# Ardersier planning update

It was identified last year that the tallest structure that has been built within the upgraded Ardersier Waste Water Treatment Works is higher than allowed by the planning consent for the development.

Photos showing Picket Fence Thickener tank as currently installed, before proposed reduction in height. Above: from the north on the coastal path. Below: from the north on the B9006.

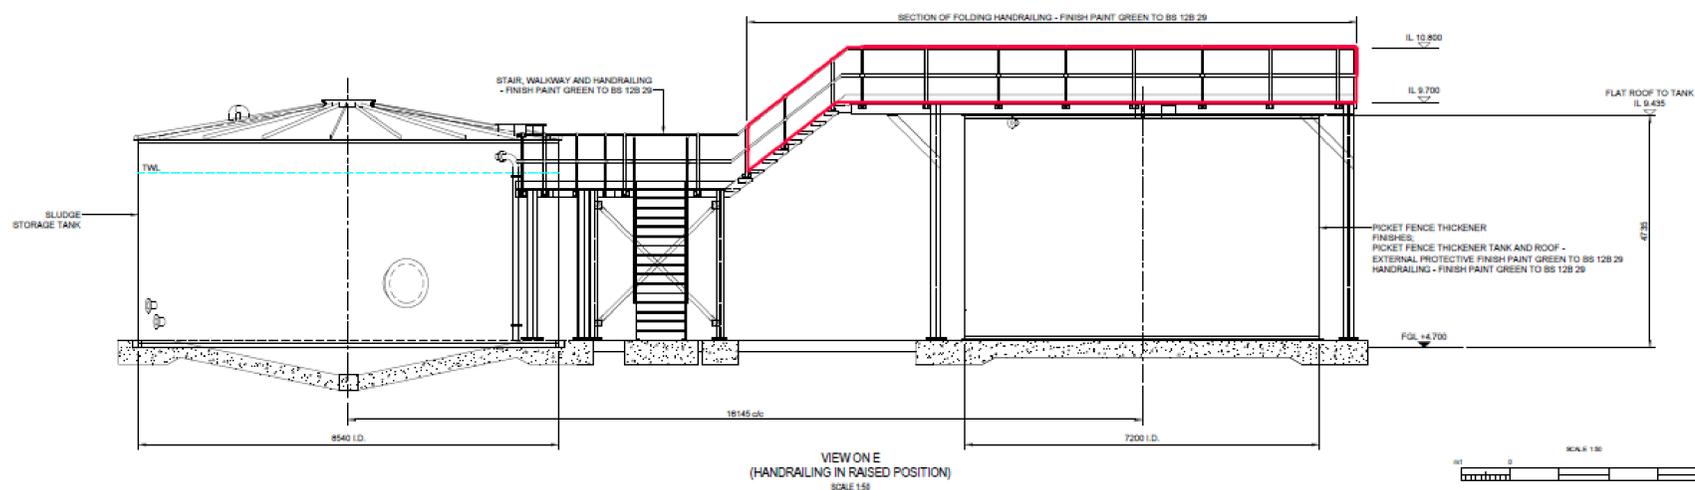
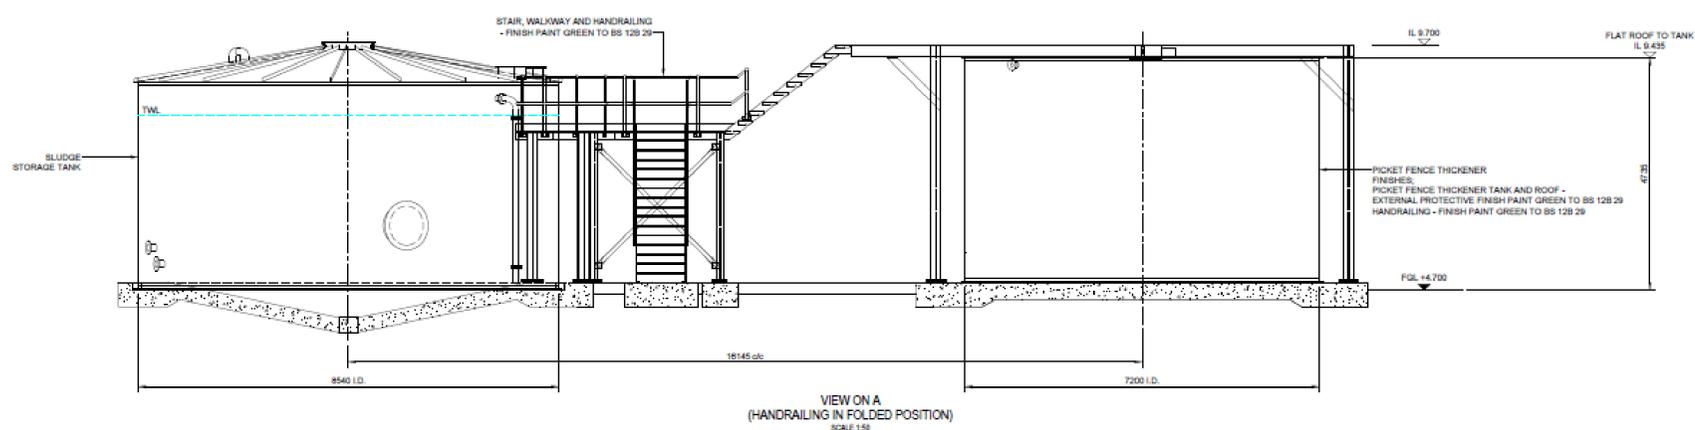
In response to feedback from the CLG, Scottish Water has agreed to lower the structure so that the height complies with the existing planning permission. This work will be carried out once approved by the planning authority.

A folding handrail would be used on the access gantry (indicated below in red) which would only be in the upright position for infrequent access by operators.

## Elevations showing proposed revision to Picket Fence Thickener

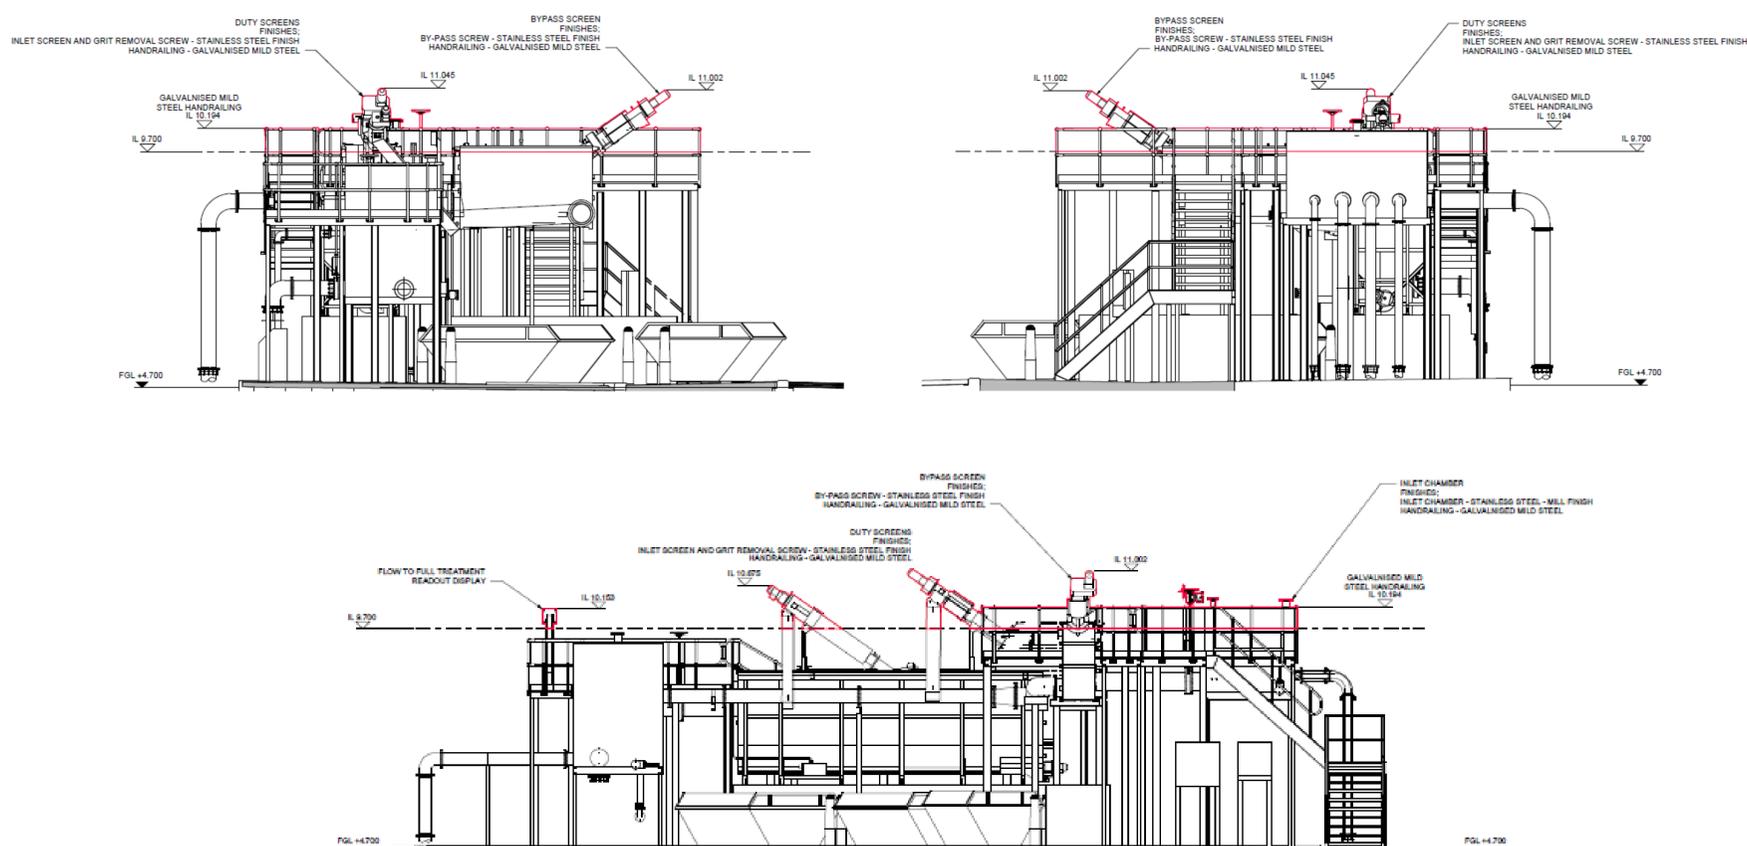
(Above: handrail folded down in normal operation. Below: handrail shown in raised position to allow infrequent maintenance access.)
